Meeting Agenda

Historic Zoning Commission

Monday, November 14, 2022

① SITE PLAN // PROPOSED
1/16" = 1'-0"

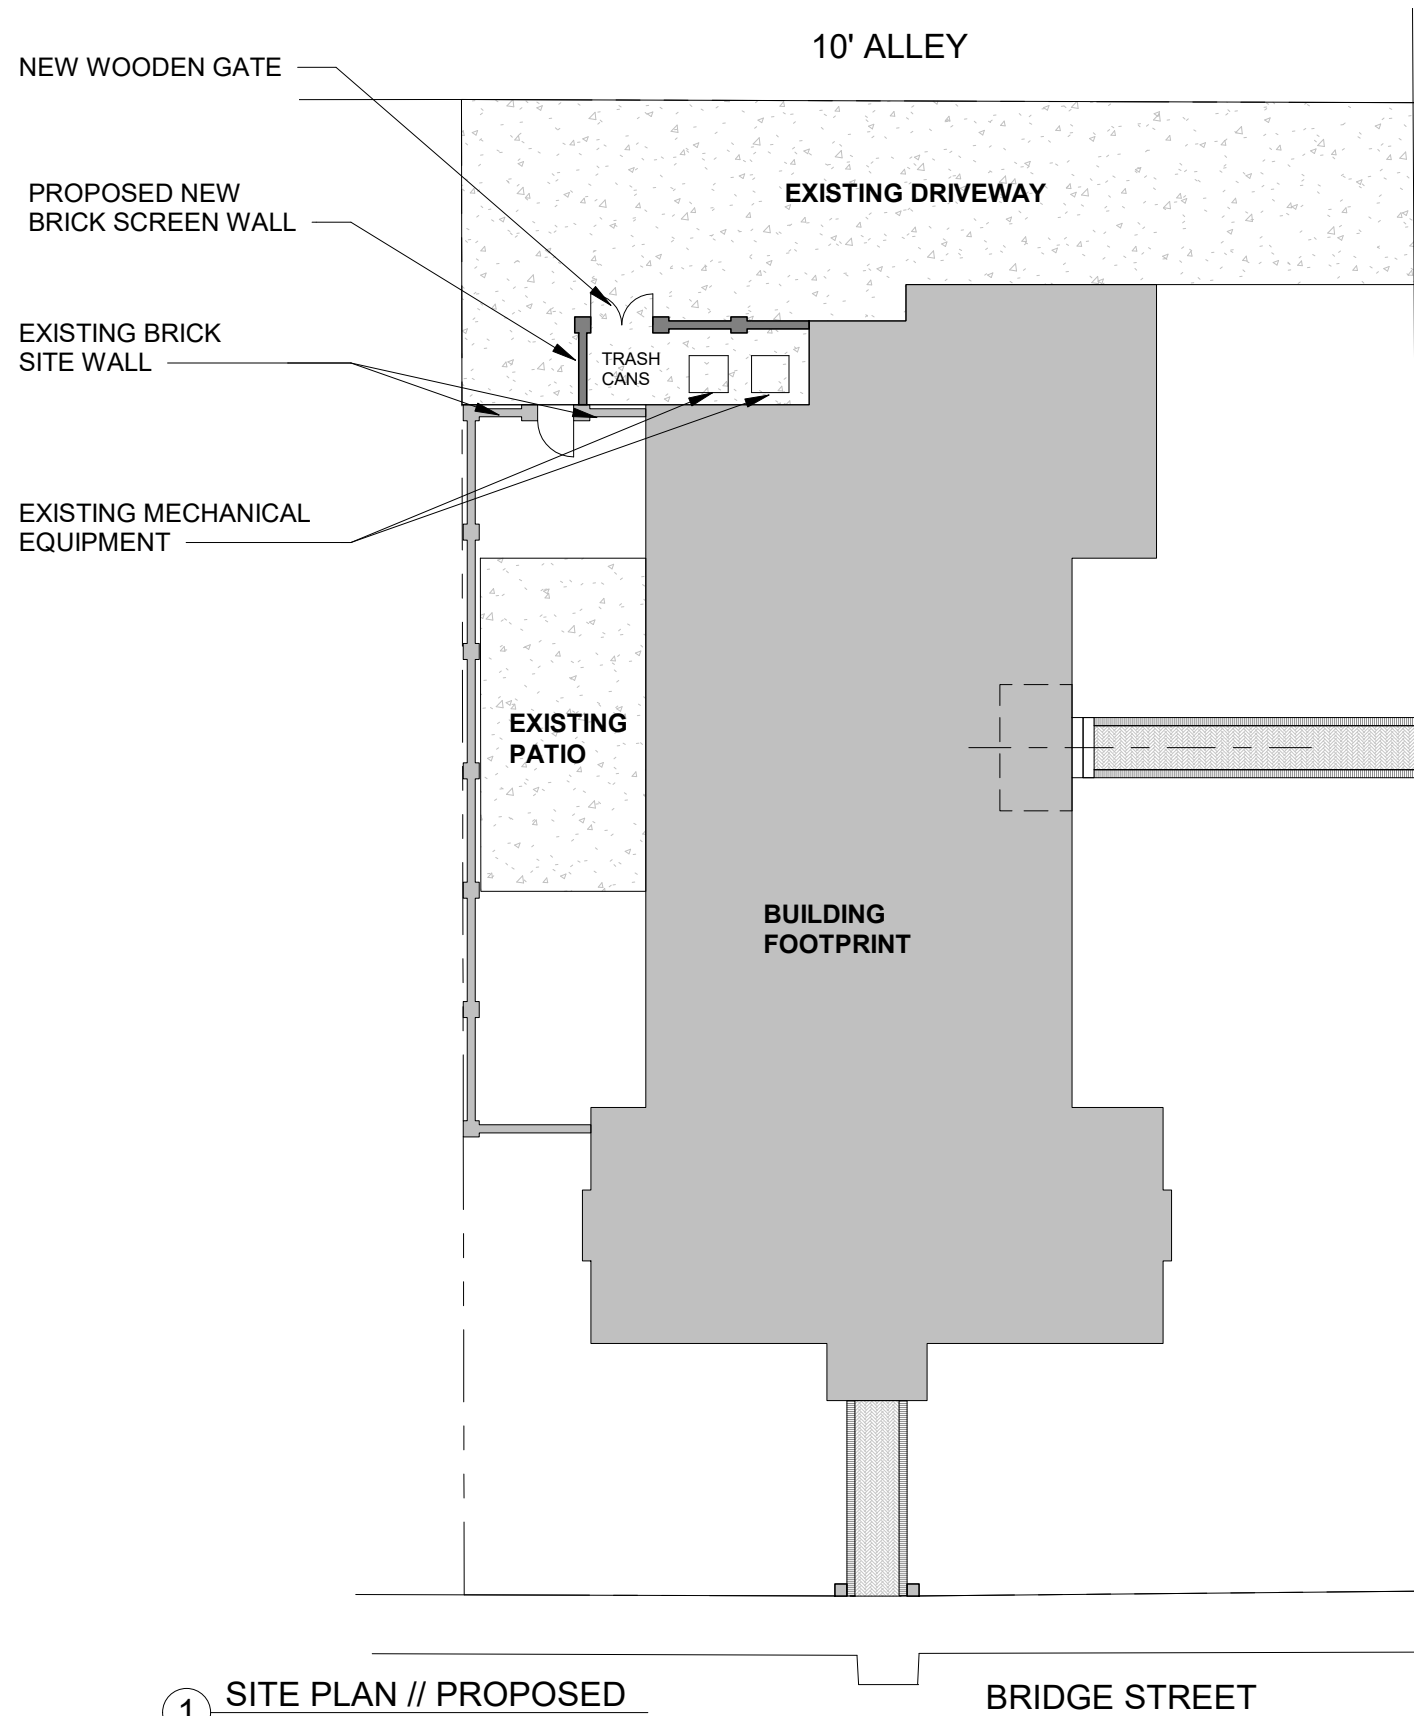
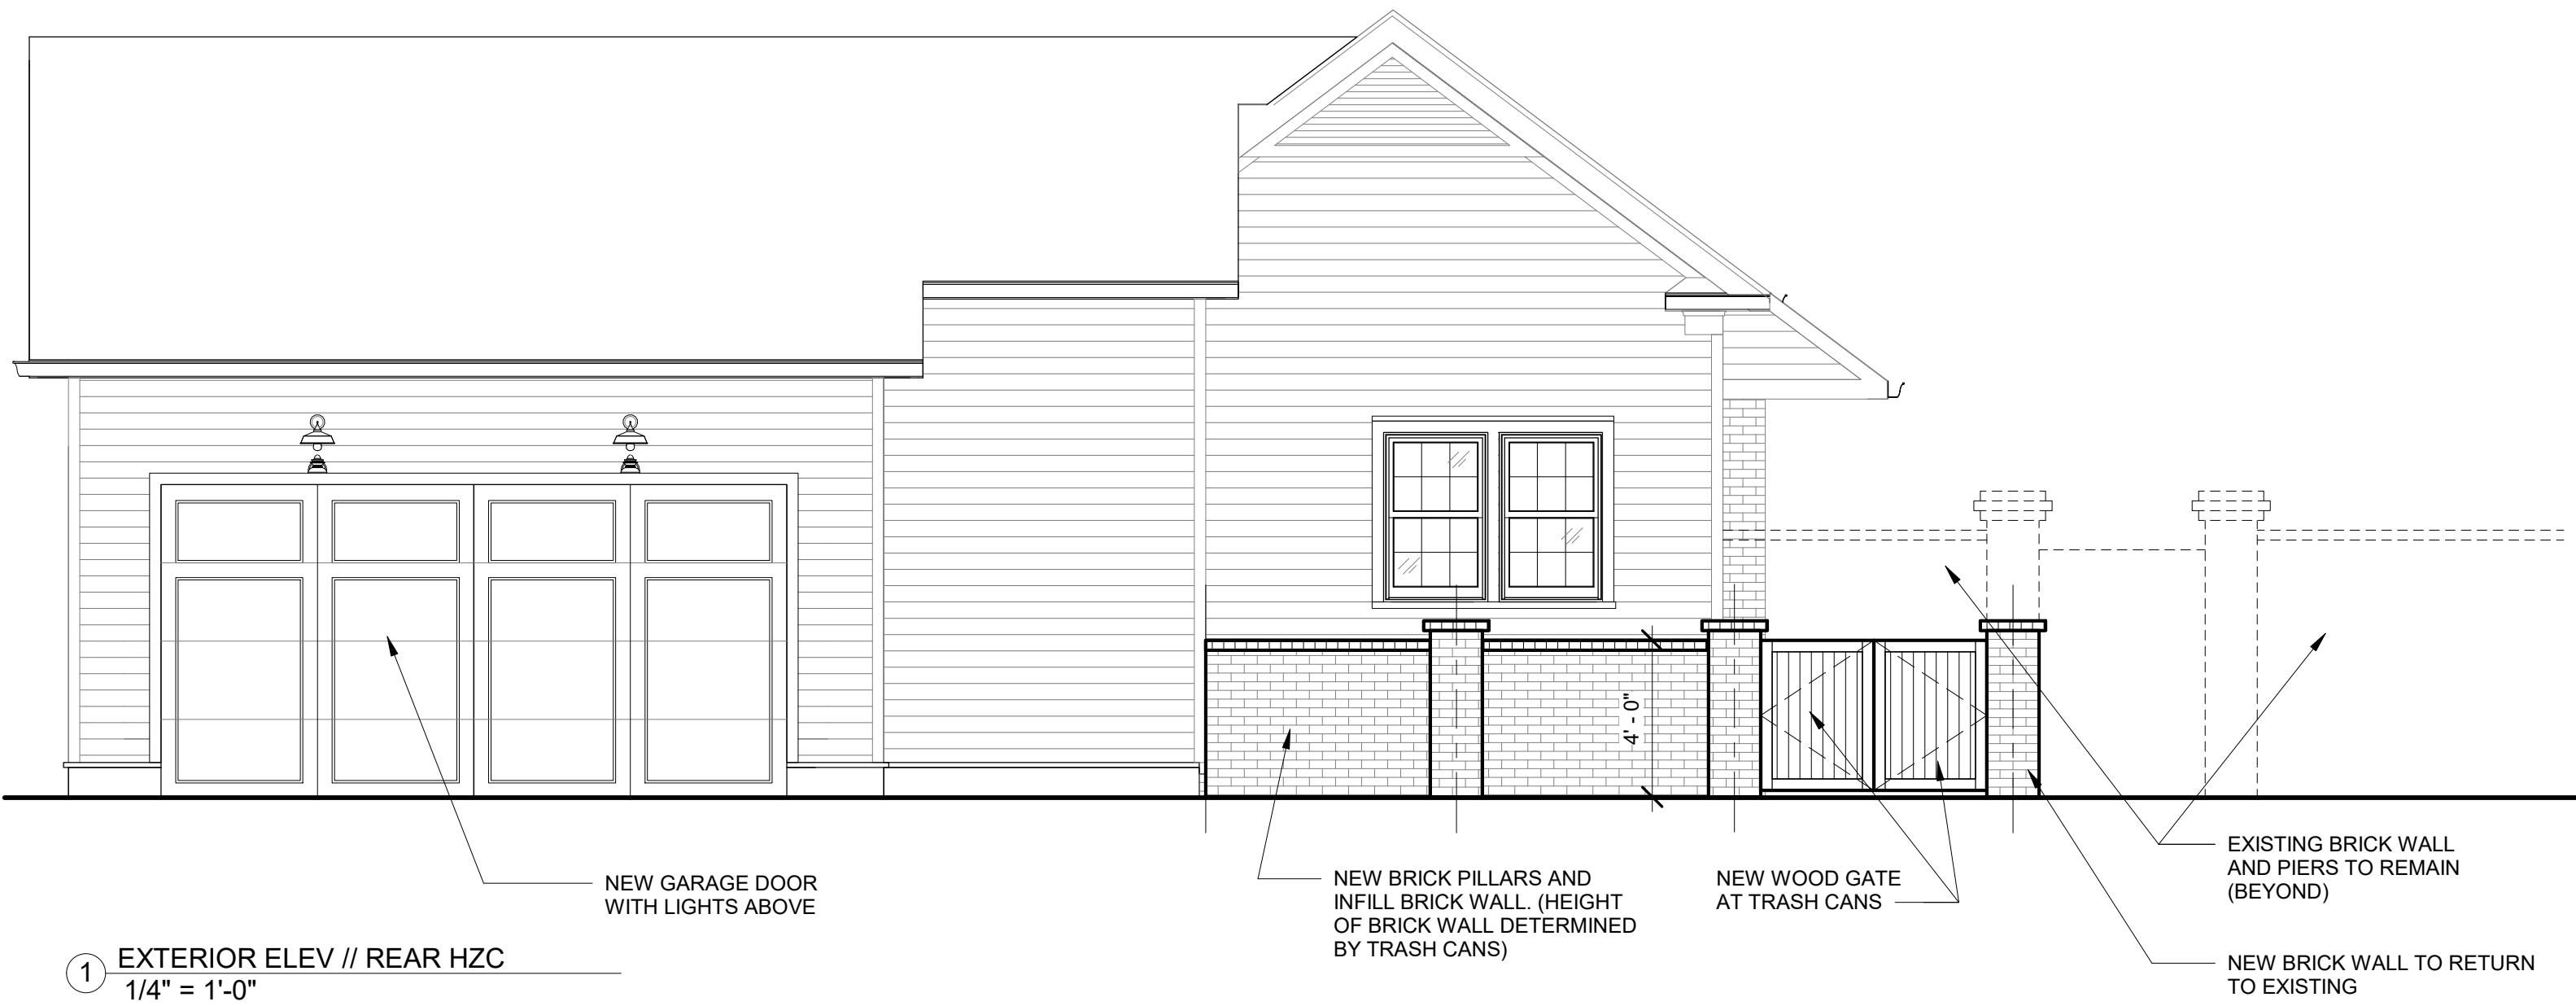
The Guidelines recommend that mechanical equipment be concealed behind buildings or to be screened from street view with landscaping, fencing, or walls. As such, the proposed wall request appears to be consistent with the Guidelines.

1. The brick must be consistent with the existing brick wall and pillars on the property. A sample of the brick must be submitted to the Preservation Planner for review and approval prior to work commencing.
2. The wall height cannot exceed 7' in accordance with the Zoning Ordinance.
3. The application must meet all the requirements of the City of Franklin prior to work commencing.
4. Any additional changes to the approved plans must be returned to the Preservation Planner or the Historic Zoning Commission for review and approval.
